**REGULAR MEETING OF THE
DESIGN REVIEW BOARD**

September 06, 2023 at 7:30 p.m.

- 7. PUBLIC HEARING – 444 KEARNEY STREET TIER III DESIGN REVIEW**
Application: PL22-0068
Applicant: Robert Wolf
Location: 444 Kearney St.
APN: 504-510-026
Zoning: Transit-Oriented Higher-Intensity Mixed Use (TOHIMU)
General Plan: Transit-Oriented Higher-Intensity Mixed Use (TOHIMU)
Request: Design Review Board consideration of Tier III Design Review for increasing the height of an existing structure by 6 feet and creating a live work unit.
CEQA: This project is categorically exempt from the provisions of CEQA pursuant to Section 15332 of the CEQA Guidelines, Class 32: In-fill Development Projects.

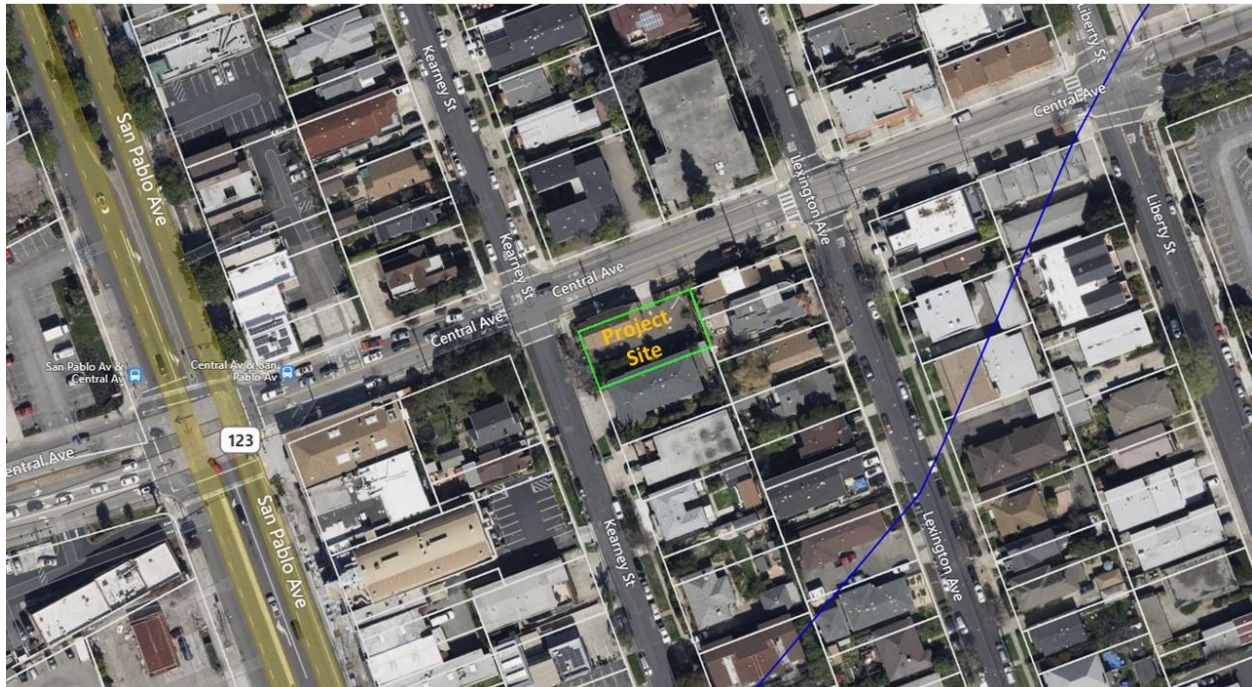
In response to Design Review Board comments on June 7, 2023, the applicant updated their application to include a more detailed landscape plan, more detailed fence elevations, and revised the porch design so that it now includes a gabled roof.

Previously Proposed West Elevation

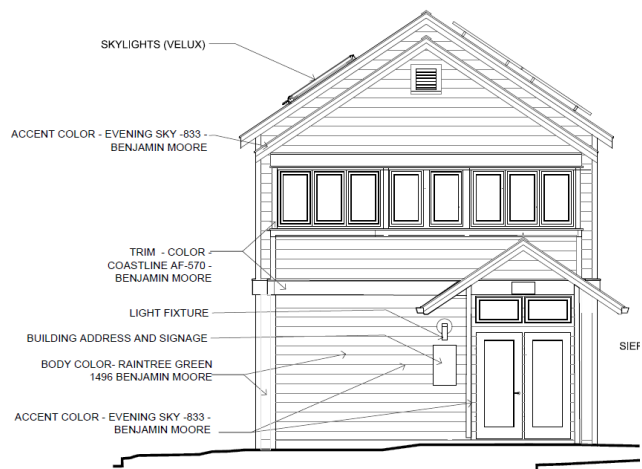
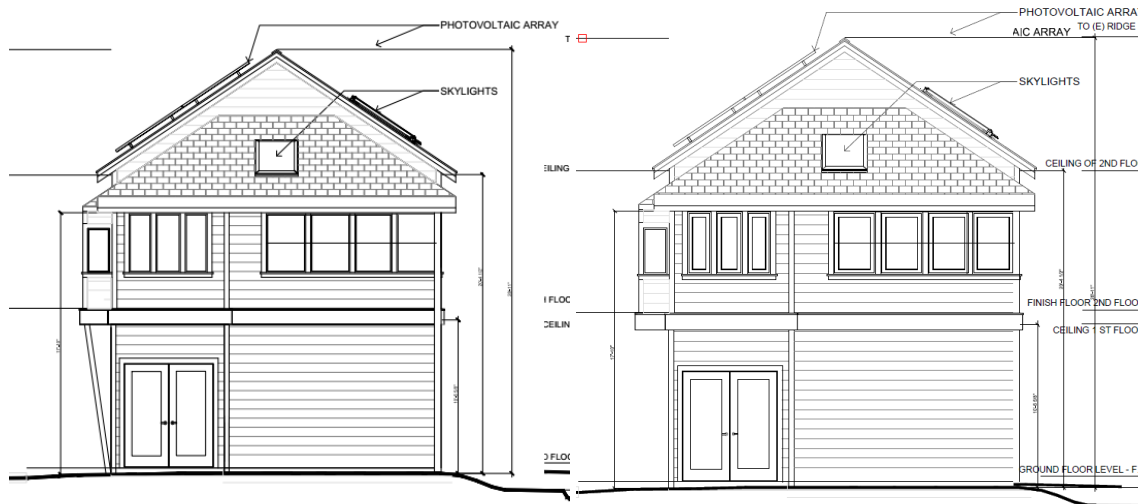
On June 7, 2023, the Design Review Board reviewed the application and continued the item to August 2, 2023. The applicant needed additional time to incorporate the changes requested by the Design Review Board, so the meeting was postponed to September 6, 2023. The Design Review Board directed the applicant to provide more information, more detailed landscape plans, to provide elevations for any new proposed gates or fences, to consider a different porch design, and for the site plan to show all of the overhangs.

In response, the applicant provided a revised proposal addressing the points raised at the July 7, 2023 Design Review Board hearing. The applicant provided a revised landscape plan showing specific plants that are being proposed and the locations where they are being proposed. The current landscape plan is proposing the following plants: *Aloe pluridens* (French Aloe), *Comarostaphylis diversifolia* (Summer Holly), *Furcraea macdougallii* (MacDougall's Century Plant), *Garrya elliptica* (Silktassel Tree), *Prunus ilicifolia* (Catalina Cherry), *Rhus integrifolia* (Lemonade Berry), *Aloe plicatilis* (Fan Aloe), *Ceanothus 'Skylark'*, *Crassula ovata* (Jade Tree), *Cussonia spicata* (Cabbage Tree), *Aeonium arboretum* (Aeonium), *Aeonium simmsii* (Simm's Drawf Aeonium), *Agave bracteosa* (Candelabrum Agave), *Eriogonum Grande V rubescens* (Red-Flowered Buckwheat), *Kalanchoe fedtschenkoi* (Lavender scalops), and *Iris douglasiana* (Douglas Iris). The applicant also provided a revised site plan which more acutely matches the proposed elevations and included elevations for the proposed gate design along Central Avenue. The applicant also revised the porch design so that it now includes a gabled roof, and they provided more information on the proposed windows which are Sierra Pacific Aluminum Clad windows. The images below show a comparison of the previously proposed elevations and the revised elevations. Proposed landscape changes can be seen on Sheet L2.1 and L2.2 of the attached plans.
